Project	IEEE 802.16 Broadband Wireless Access Working Group < http://ieee802.org/16 >	
Title	Idle Mode Location Update Enhancements	
Date Submitted	2004-06-25	
Source(s)	Hang Zhang, Mo-Han Fong, Peiying Zhu, Wen Tong	mhfong@nortelnetworks.com
	Nortel Networks 3500 Carling Avenue, Ottawa Ontario, Canada K2H 8E9	Voice: +1-613-765-8983 Fax: +1-613-765-6717
Re:	IEEE P802.16e/D3-2004	
Abstract	This contribution proposes enhancement to Idle Mode location update	
Purpose	Review and Adopt the suggested changes into P802.16e/D3	
Notice	This document has been prepared to assist IEEE 802.16. It is offered as a basis for discussion and is not binding on the contributing individual(s) or organization(s). The material in this document is subject to change in form and content after further study. The contributor(s) reserve(s) the right to add, amend or withdraw material contained herein.	
Release	The contributor grants a free, irrevocable license to the IEEE to incorporate material contained in this contribution, and any modifications thereof, in the creation of an IEEE Standards publication; to copyright in the IEEE's name any IEEE Standards publication even though it may include portions of thi

Fig. 1. BS initiated location update.

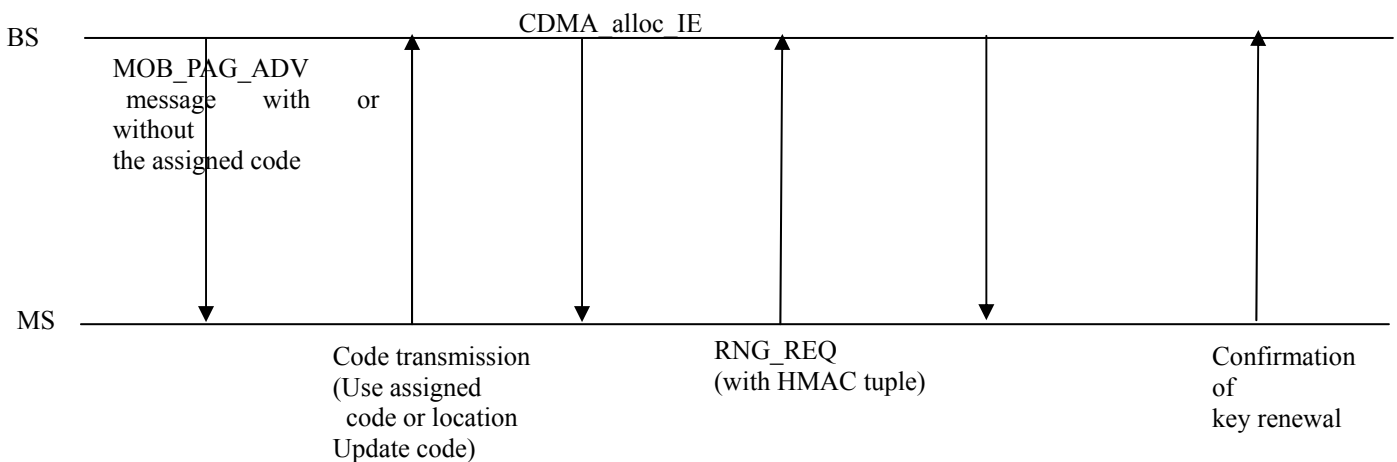
- For a BS initiated location update, when a BS sends the paging (MOB_PAG_ADV), optionally, a code can be assigned to a MSS for use by the MSS to perform ranging. If a code is assigned, the MSS shall use the assigned code to perform initial ranging for the purpose of location update. If a code is not assigned, the MSS shall use the location update/handover codes, which is a set of codes reserved for MSS-initiated location update/handover purpose.
- Optional renewal of authentication key can be performed during location update

The procedures for location update initiated by BS is illustrated in Fig. 1.
